Revised August 11, 2008

Subtask 2.3. Track, Signal and Grade Crossing

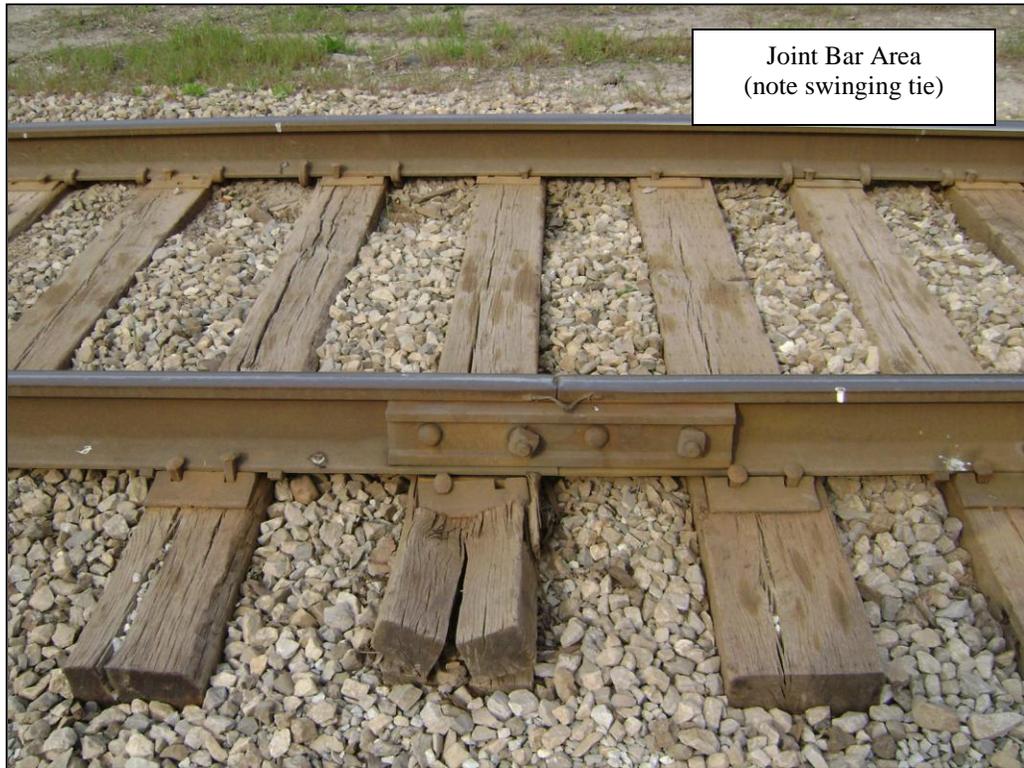
Additionally, a mid-day layover track is proposed to be constructed at the east end of Osmer Siding (see photo at top of next page) consisting of a hand-throw switch (off of the siding) providing access to a single 5,000 foot side track. Standby power would be supplied at this location as well. Access to this layover track would be by gravel road.
